Service Letter #: SL07-35A-45050 Shear Pin

Date: 09/02/14

Part/Assembly #: 35A-45050 Shear Pin

Float Model/Aircraft Affected: Aerocet Model 3400 Amphibious Floats, Serial #330 and later, and any earlier floats in which cotter style shear pins have been replaced with the retaining ring style. (35A-45050, I/R is cotter pin style, while 35A-45050, Rev A is retaining ring style.)

Figure 1 - Showing Main Landing Gear and 35A-45050 Pin Installation

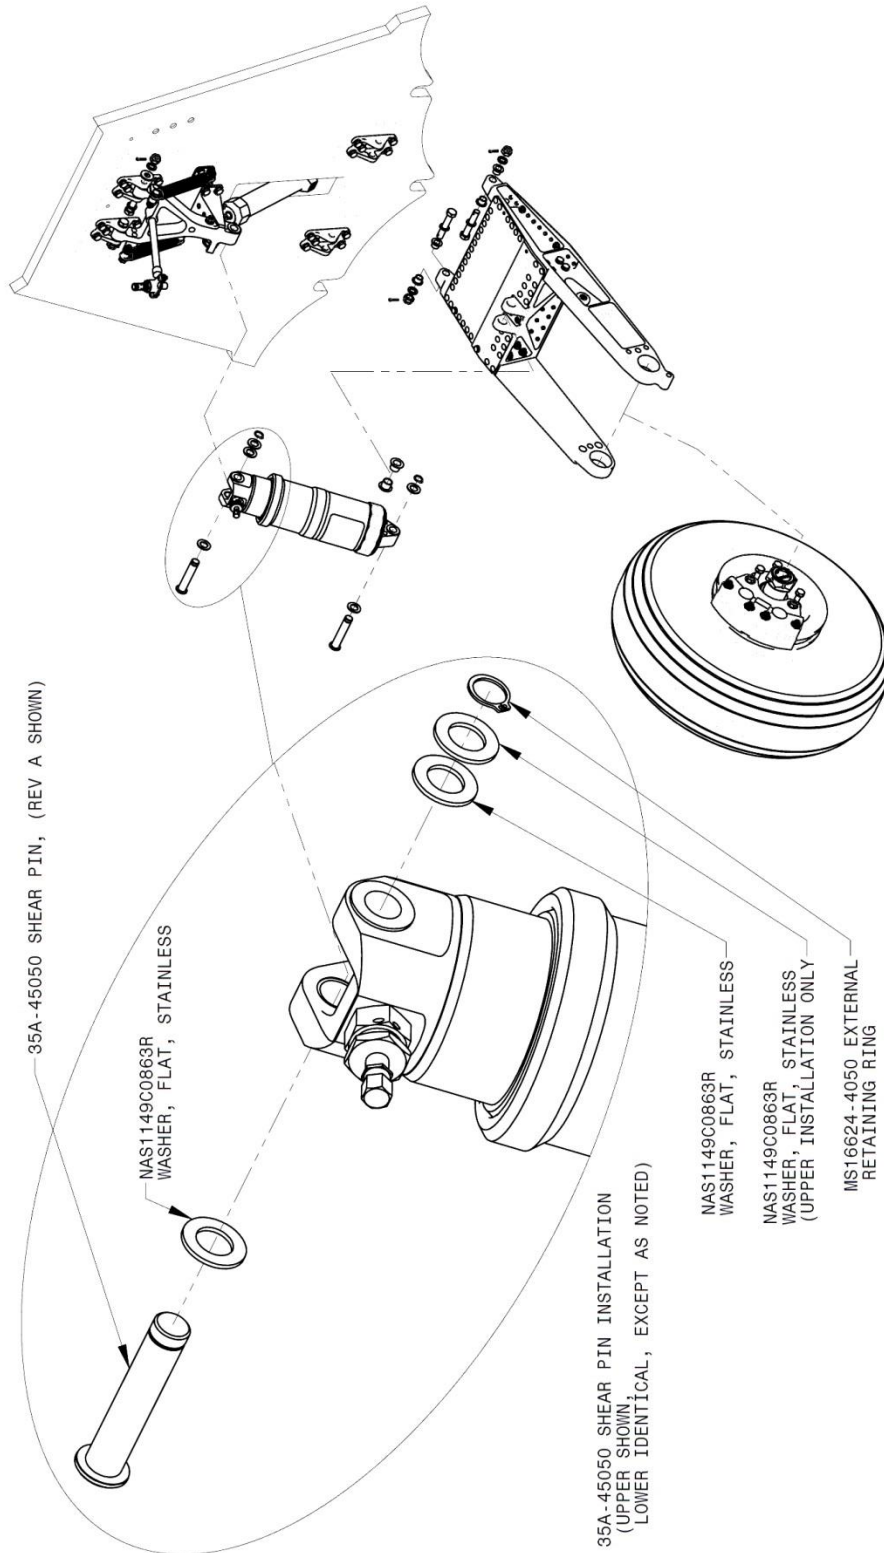
Symptom: MS16624-4050 Retaining Ring yielded due to over-spreading on installation.

It has been discovered that mechanics have overstretched the retaining rings that hold these pins in place upon either installation or removal of the shock strut reducing their retaining ability. As a result, retaining of the shock strut connecting pins may be lost.

Assure that the connecting pins for the main gear shock strut (oleo) are secured (both top and bottom) with their respective retaining rings (Circlips, snap rings). (See Illustration on following sheet)

A further examination should be done by reaching in and rotating the retaining ring(s). If the retaining ring(s) rotates easily (no drag) then it likely has been overstretched and should be replaced.

Any reinstallation of these connecting pins should be done with new retaining rings.
